Commentor No. 584: Mark Wahl

Please accept the following as public comments incorporated into the formal administrative record and taken into consideration when adopting the final record of decision on the Draft Environmental Impact Statement on the Nuclear Infrastructure EIS.

Response to Commentor No. 584

Figure 4 PTP and HFIR Flux Spectra Comparison

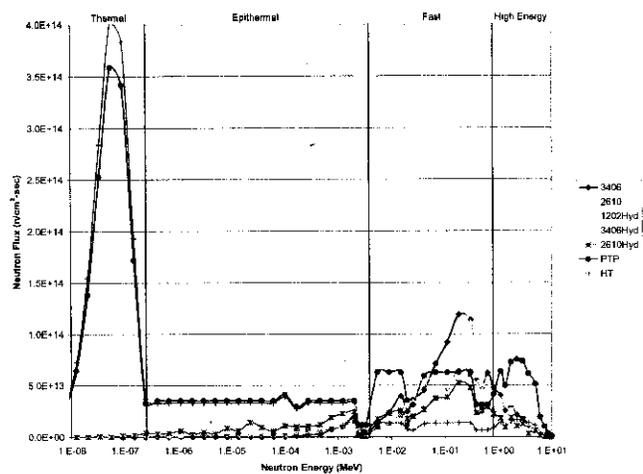
There are several reasons why FFTF and HFIR provide superior capabilities relative to conventional water-cooled nuclear reactors. The primary advantage these reactors possess is their neutron flux. As seen in this graph of neutron energy versus neutron flux, the FFTF and HFIR flux spectra have significant epithermal, fast, and high energy components. This is not the case for conventional thermal reactors which have essentially zero flux in these regions. This is significant because many medically important isotopes have large production cross sections in the epithermal region. For these isotopes it should be noted that FFTF's flux can be tailored to match the absorption resonances of the target isotopes in the epithermal region to dramatically increase production. Further, the fast and high energy neutrons allow the production of certain isotopes via reactions that can not occur in conventional water-cooled reactors. For example, Cu-67 can be produced with a very high specific activity by taking advantage of energetic neutrons. Cu-67 is typically produced by the absorption of a neutron by Cu-66. However, that reaction produces ~~if~~ Cu-67 that is contaminated by many other isotopes of copper which results in a low specific activity since Cu-67 can't be chemically separated from its other isotopes. In FFTF and HFIR, a Zn-67 target can absorb a neutron and eject a proton to become Cu-67 which can then be chemically separated from the zinc target to produce a very high specific activity product. As seen in this graph of reaction probabilities, the neutron-proton reaction requires an energetic neutron and essentially does not occur at all in conventional water-cooled reactors. Another advantage related to flux is the overall substantial flux level. Both reactors have much higher total fluxes than conventional water-cooled reactors which provides the ability to produce high specific activity isotopes in neutron capture reactions.

991-2: DOE recognizes the high energy neutron flux spectrum of the FFTF and HFIR reactors as compared to the neutron flux energy spectrum of other nuclear reactor designs and the desirability of this higher energy flux in producing certain radioisotopes. In addition, DOE is aware of the available irradiation volumes for each alternative analyzed in the EIS. The high energy accelerator alternative could also theoretically provide a high energy neutron flux for radioisotope production but the current design and size of the accelerator evaluated in the NI PEIS does not support this. The operational status of FFTF and HFIR, along with their relatively higher energy flux spectrum and large irradiation volumes, will be considered in the DOE decision making process.
